**PLANNING COMMISSION
REGULAR MEETING
MARCH 5, 2025
6:00 pm**

TO: Planning Commission
 FROM: Corey Christensen, Senior Planner
 MEETING DATE: February 26, 2025
 RE: Preliminary Site Plan: Light Manufacturing, 49730 Woodward Avenue

SPR 25-002 is a request for site plan approval by Chris Toma to allow for light manufacturing at 49730 Woodward Ave. The building is existing and the applicant is proposing to reduce it's footprint and expand the parking available on site. Currently, the property owner does not have a specific user identified for the site and the applicant is seeking approval for light manufacturing uses broadly. If a user is selected that wants to use the property for a use outside of the light manufacturing classification, new approvals will need to be secured.

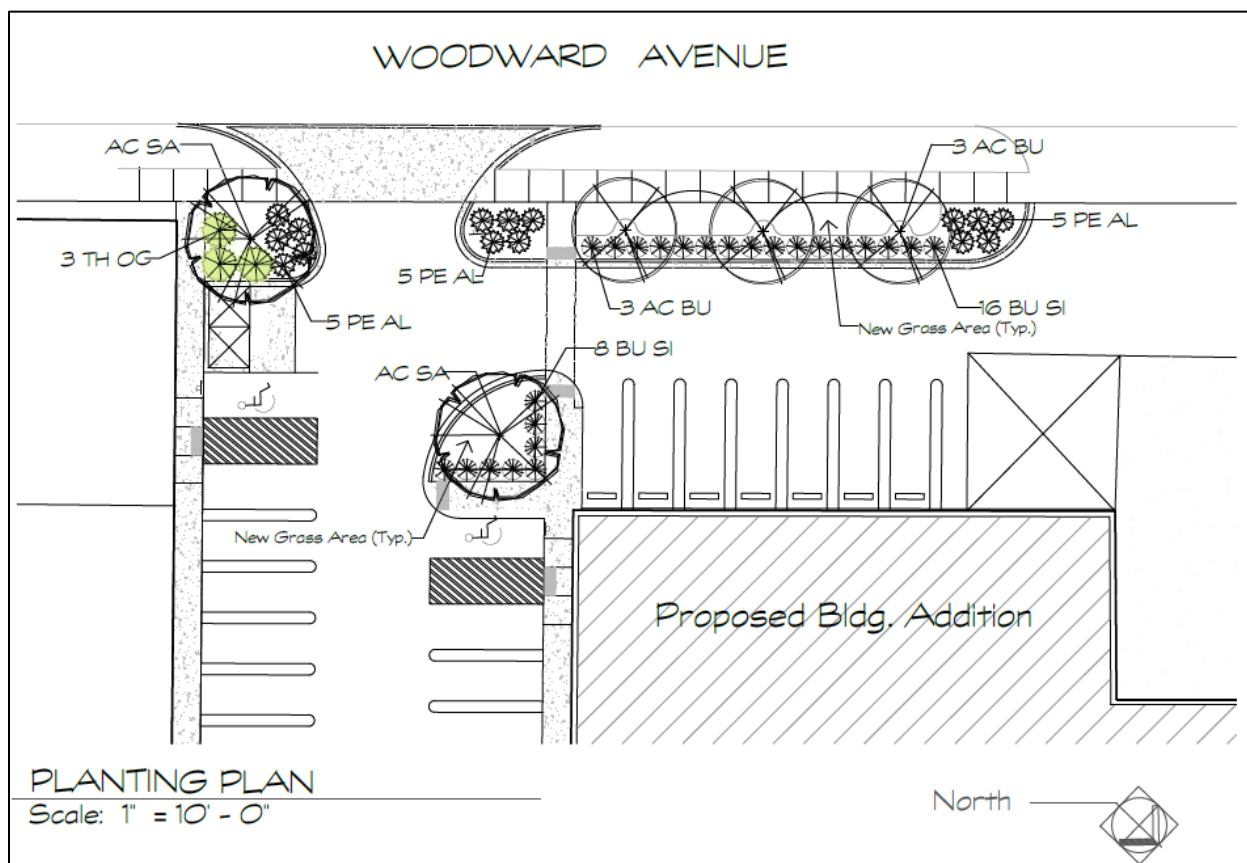
4.302(C) LOCATION OF PARKING SPACES – The site plans indicate a parking lot will be provided to

across Woodward Avenue, however, the ordinance does not allow off-site parking spaces if it is across a major thoroughfare. **For this reason, only the 27 parking spaces provided on-site count toward meeting the 60 parking space requirement – a 33 space deficiency. The applicant will need to secure a parking waiver, variance, or reconfigure their site plan to meet the parking requirement.**

4.303(F) BICYCLE PARKING – At least one bike space must be provided per every 20 parking spaces. **The site plans should be revised to provide the required number of bike spaces.**

4.305(E) PARKING SPACE AND MANEUVERING LANE – **The site plans should be revised to provide the width of each maneuvering lane.**

4.305(F) STRIPING REQUIREMENTS – **The site plans should be revised to provide the color the parking lot will be striped in.**

4.306 SURFACING – **Please revise the site plans to indicate what the parking lot will be striped in.**

1. The site plans will be revised to include all the informational items identified in the staff report.
2. The off-site parking lot is prohibited across a thoroughfare, per the Zoning Ordinance, and must be removed from the site plans and not part of this application.
3. The front façade must be revised before issuance of Final Site Plan to comply with the Zoning Ordinance requirements for building materials. At least 60% of the façade (not counting windows and doors) must be composed of primary building materials, no more than 10% may be composed of accent materials, and there must be at least 40% transparency.
4. At least one bike space must be provided for every 20 parking spaces.
5. Planning Commission grants a waiver of 33 parking spaces.

NORTH ELEVATION
SCALE: 3/32"=1'-0"

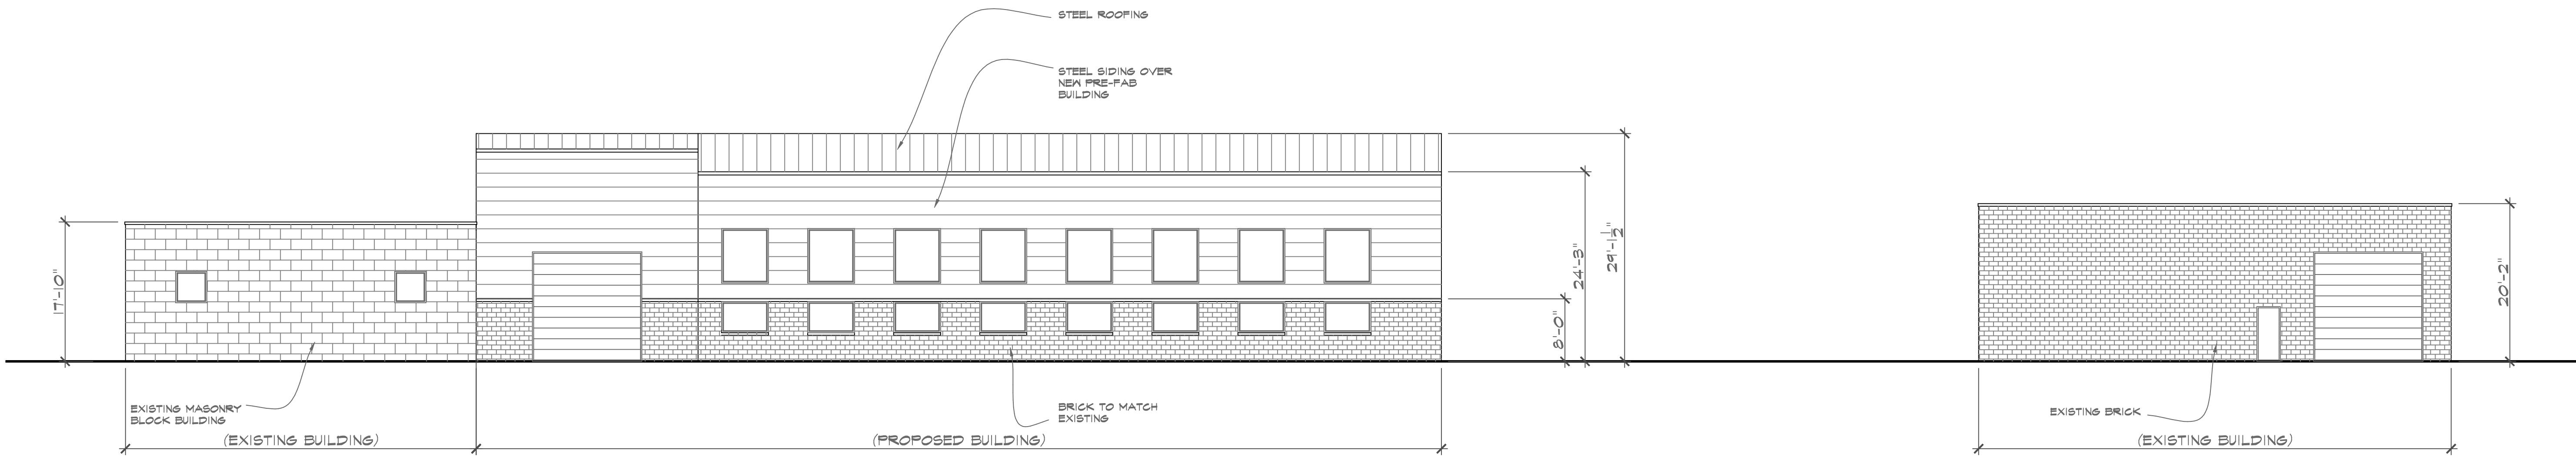
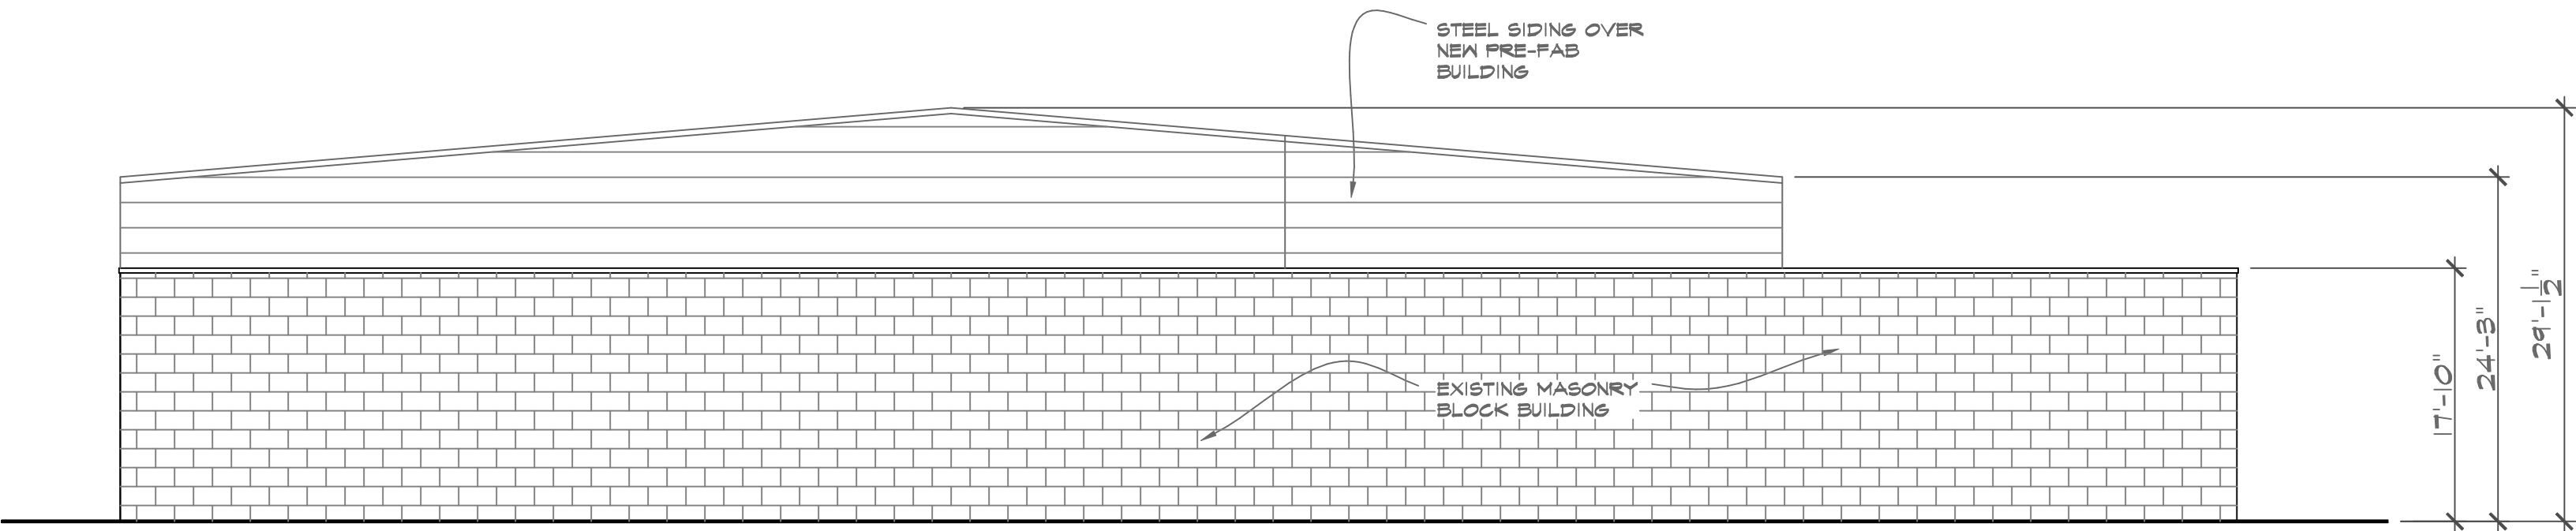
2.408 STREETFRONT – The existing front façade that is being retained is grandfathered, but the portion that is new build will need to comply with the design requirements of the zoning ordinance. **The plans will need to be revised to provide the area of each building material on the front façade. Primary building materials (brick, masonry block) may not be less than 60% of the façade, while accent materials (metal) may not compose more than 10%. Please provide the area of transparency on the front façade, there must be at least 40% transparency. Please provide a statement that no mechanical equipment will be visible.**

- I. The off-site parking lot must be removed from the site plans.*
- II. The front façade must be revised to comply with the zoning ordinance requirements for building materials. At least 60% of the façade (not counting windows and doors) must be composed of primary building materials, no more than 10% may be composed of accent materials, and there must be at least 40% transparency.*
- III. At least one bike space must be provided for every 20 parking spaces.*
